CITY OF ALBUQUERQUE

RE: 9324 Susan Avenue SE
Grading & Drainage Plan
Engineer's Stamp Date: 12/19/24
Hydrology File: L20D079

DRAINAGE AND TRANSPORTATION INFORMATION SHEET (DTIS)

GRADING & DRAINAGE PLAN
SCALE: 1" = 10'-0"

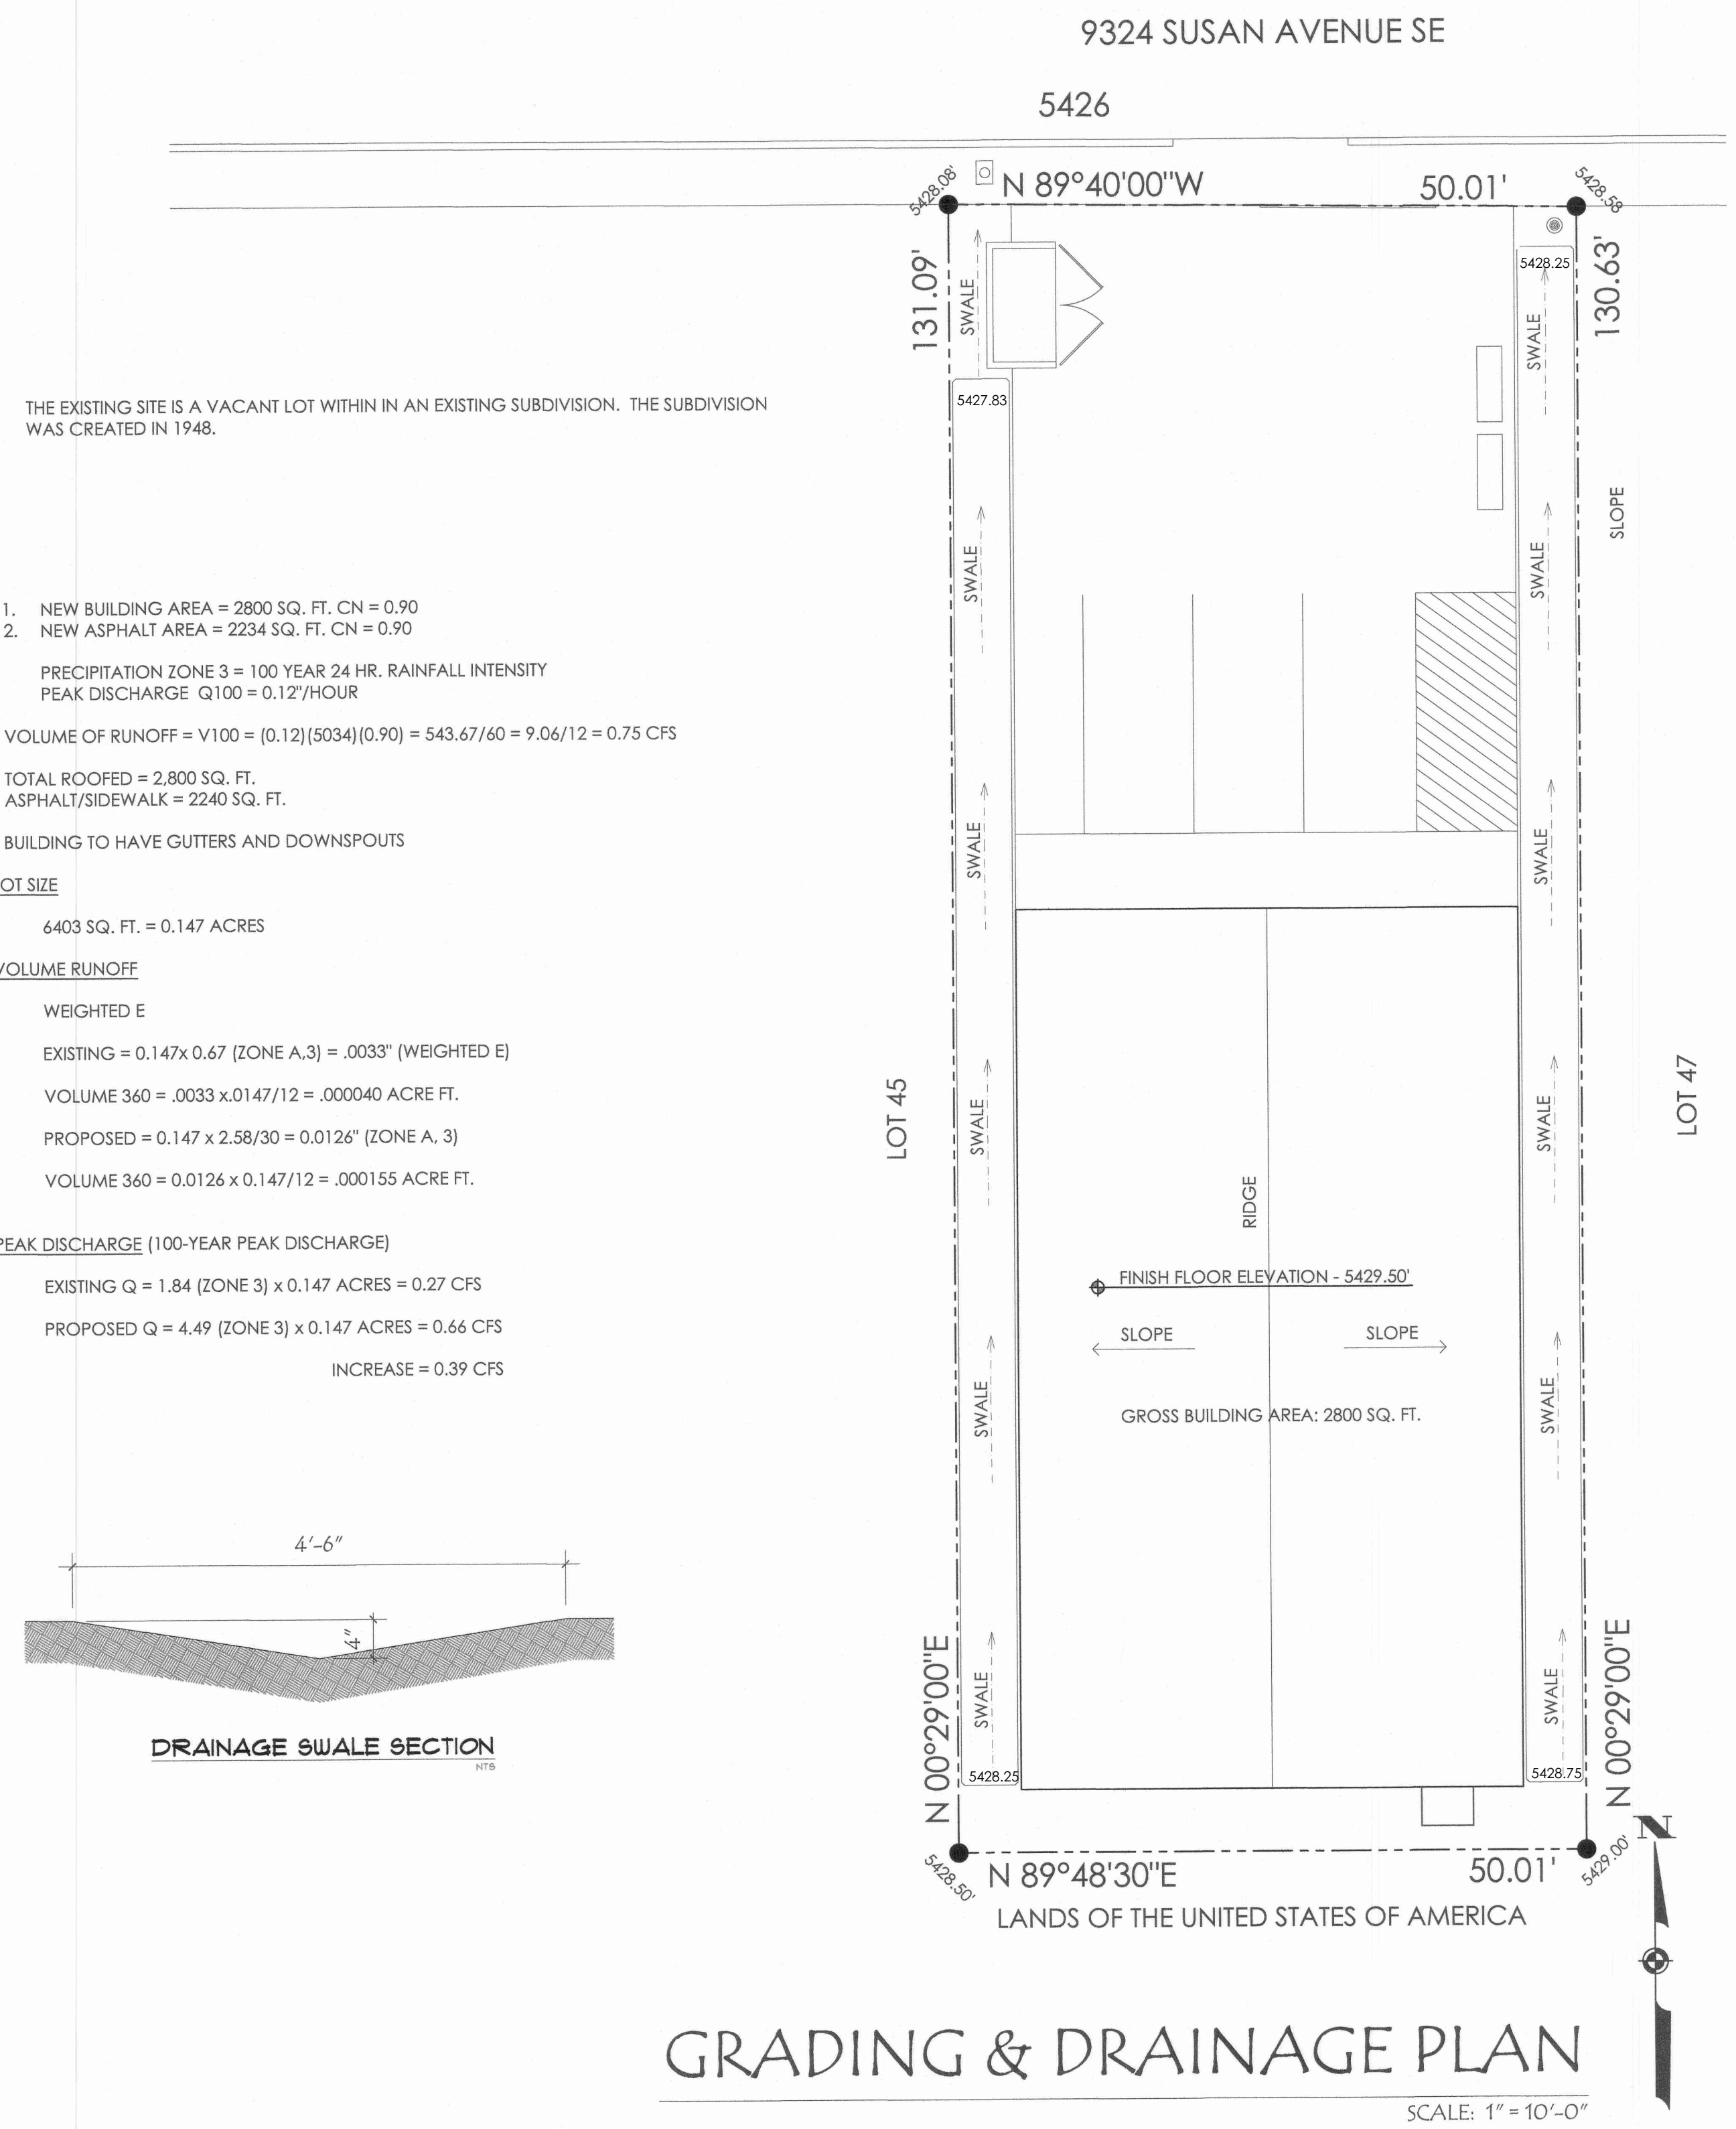
Based upon the information provided in your submittal received 12/31/2024, the Grading & Drainage Plan is **approved** for Building Permit and Grading Permit. Please attach a copy of this approved plan in the construction sets for Building Permit processing along with a copy of this letter.

1. Engineer's Certification, per the DPM Part 6-14 (F): Engineer's Certification Checklist For Non-Subdivision is required.
